National Electrical Safety Code®

# Interpretation

### **supporting structure**

(20 April 2021) IR593

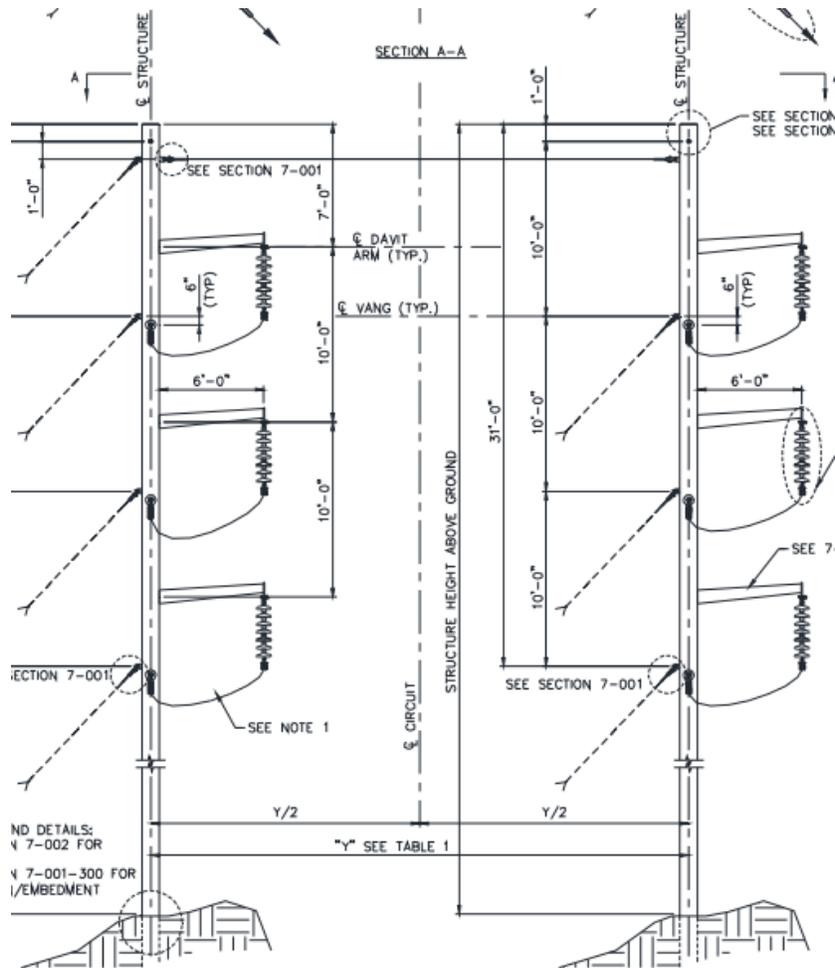
When designing a two-pole vertical deadend (see sketch in the example below), each pole is supporting its own circuit. In this case, please clarify if both poles (and their guys, if present) constitute one supporting structure or if they are independent supporting structures. If it is the former, the conductors on the left circuit need to meet “Same Supporting Structure” clearances to the pole and guys supporting the right circuit. If it is the latter, they need to meet “Other Supporting Structure” clearances to the pole and guys supporting the circuit on the right. This would greatly impact the spacing of the poles when designing such a structure.

If they are considered one supporting structure (versus two independent supporting structures), are there any specific requirements for doing so? This distinction is not provided in the code definition. In the example shown below, they are joined with a pole-to-pole guy. To be considered one supporting structure, is that required, or does it need to be a rigid member, or is that not required at all? Conversely if there were no mechanical connections, at what point would these two poles be considered independent supporting structures? Is it based on their proximity to one another, that the poles and guys are bonded (using a counterpoise for instance), or any other requirement?

The NESC provides a definition for “supporting structure” including a note with more information about what may be considered a supporting structure. However, the NESC does not provide any specifics on what criteria is needed for multiple poles or towers to be considered a single supporting structure. Since it does not provide specific information, Rule 012C applies.

It is left to the user of the NESC to determine if multiple poles or towers are a single supporting structure by using accepted good practice for the local conditions.

In general, in determining if multiple poles or towers are a single supporting structure, accepted good practice would consider the reasons and purposes behind specific NESC rules to select portions of the rules more applicable in specific circumstances. Rule 235 for “Clearance for wires, conductors, or cables carried on the same supporting structure” expects conductor attachment points to move together when the single supporting structure deflects. Rule 233 for “Clearances between wires, conductors, and cables carried on different supporting structures” allows for conductor attachment points that may move in relation to each other as these separate structures deflect independently. In determining if multiple poles or towers are a single supporting structure, accepted good practice would consider which set of assumptions is more reasonably applicable in the particular circumstance.
